EMC3 Altium Circuit & PCB layout review

Date (start) 11/22/2022
Author GKP

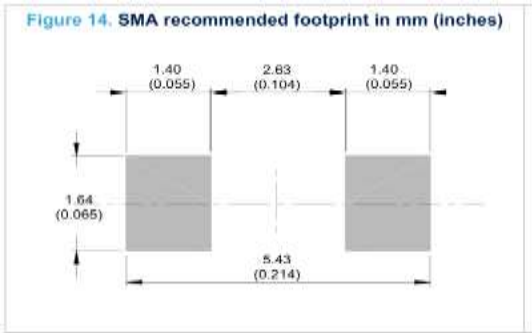
Q17 land pattern close enough.
IC2 any reason two separate voltage dividers are used instead of this?

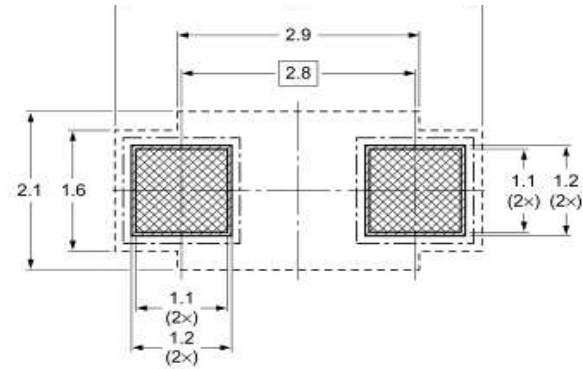
D1 This is the suggested footprint. But there are many alternatives.

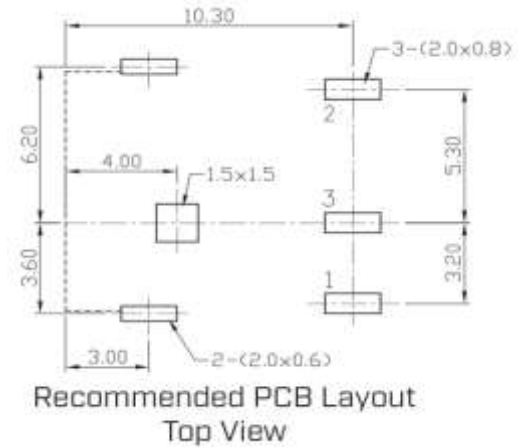
D2 This is the suggested footprint. But there are many alternatives.

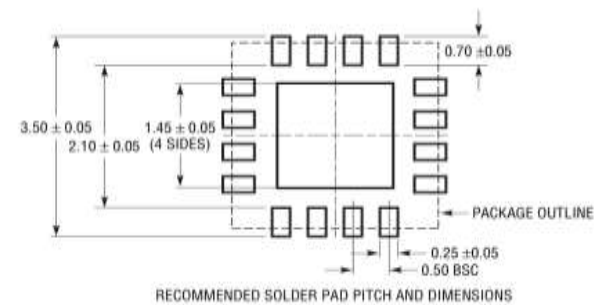
J3 Ignoring the holes instead of slots (this is normal) the footprint is the odd 0.1mm off from this

Q1 & Q2

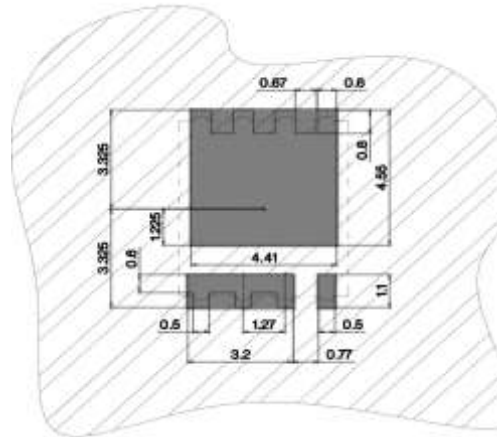
Footprint doesn't exactly match datasheet.

IC23

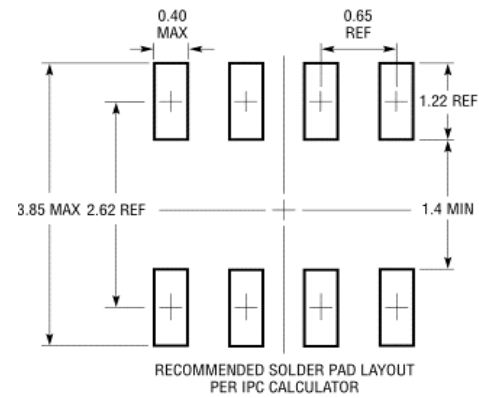
Don't know why, but the RUN signal (pin 7) doesn't seem to connect to U6 pin 1. Footprint?

C13

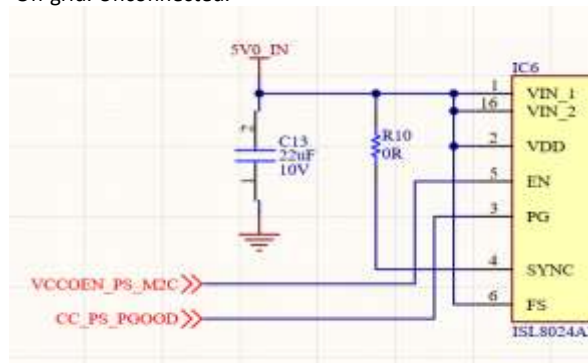
Off grid. Unconnected.

IC3, 6, 8

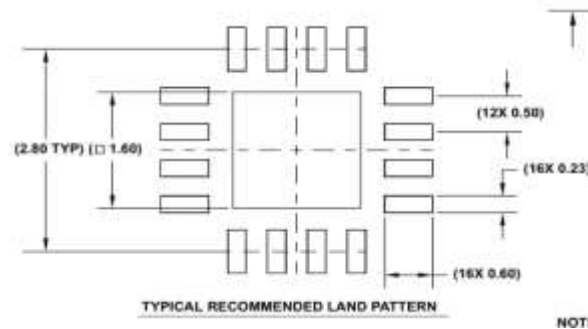
PG outputs need a pull-up.
Footprint not as per datasheet.

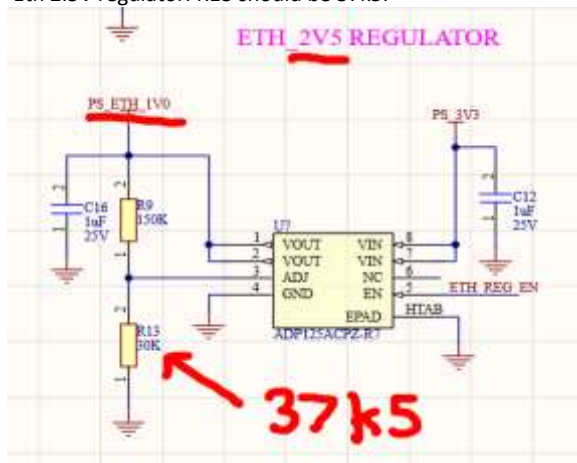
Optional 4.7pF cap across FB resistor. Add a placeholder but do not fit.
 Eth 2.5V regulator. R13 should be 37k5.

IC11

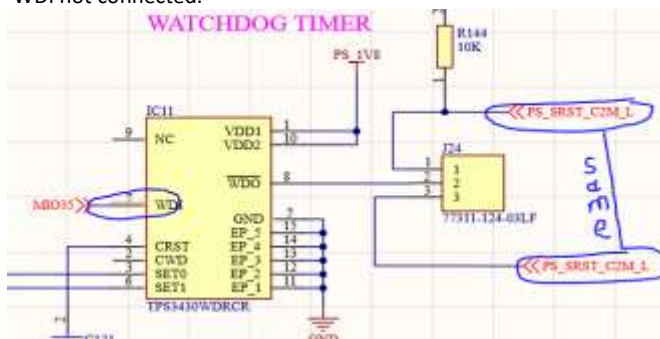
WDI not connected.

IC30

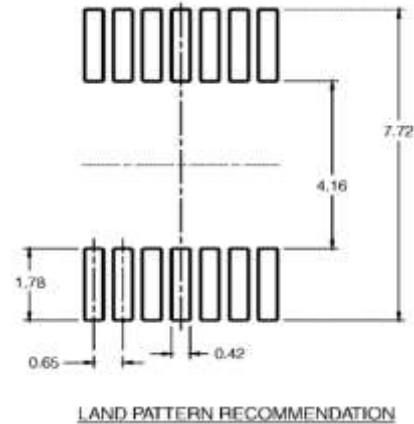
Footprint not as per datasheet.

IC16

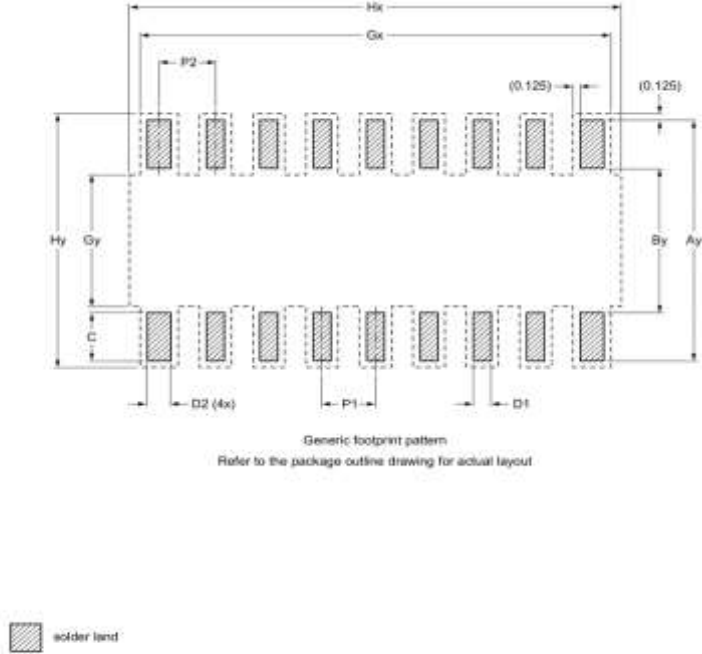
Pinout not exactly as per datasheet, but close enough

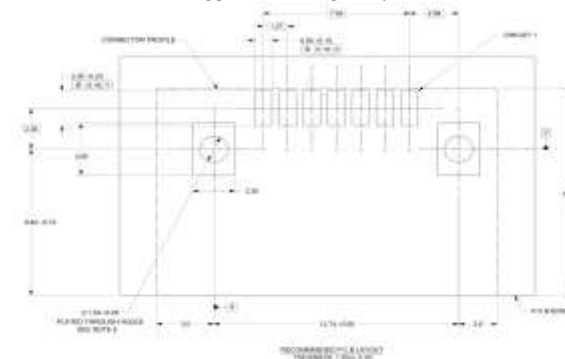
J13 Molex datasheet suggests rectangular pads for the mounting pins.

J12

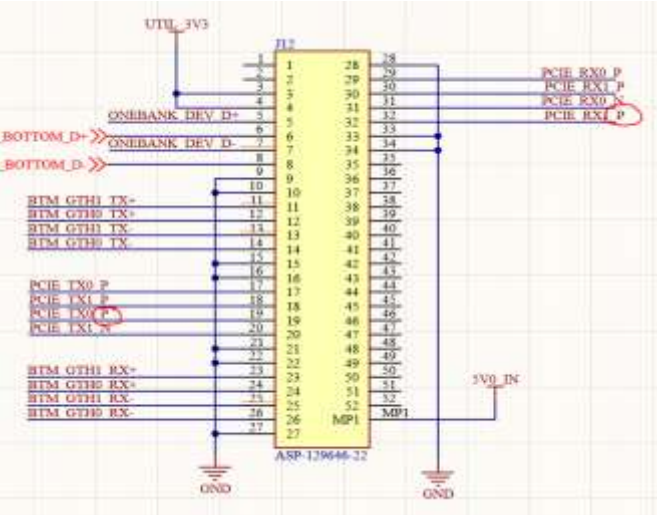
Too many Ps. Footprint checked OK.

Easier to read if the schematic symbol matches the physical connector.

IC27

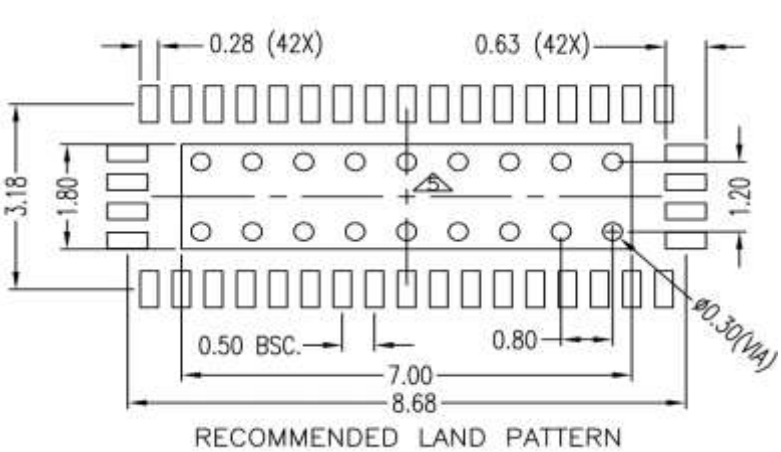
Footprint not as per datasheet.

Don't forget the vias in the central pad.

IC28

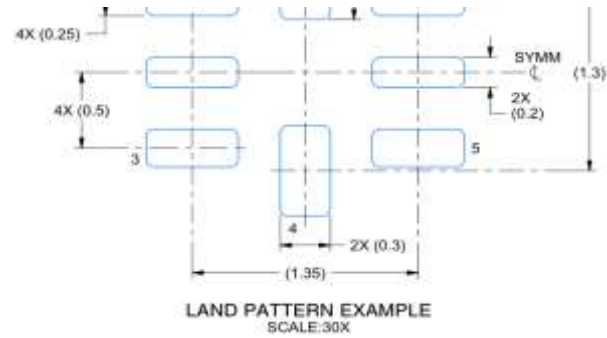
Footprint not as per datasheet.

IC31

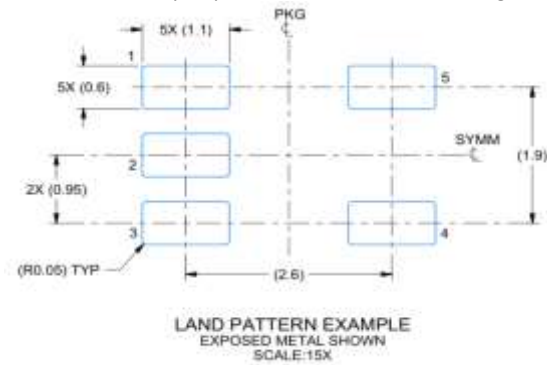
Pinout not exactly as per datasheet, but close enough

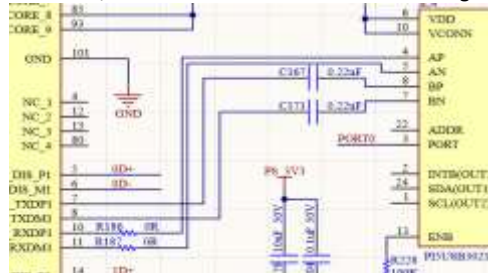
- IC22 Pinout and footprint checked OK.
Check TX/RX connection. Your cct has TX through caps to BP/BN. Pericom shows TX through caps to AP/AN.
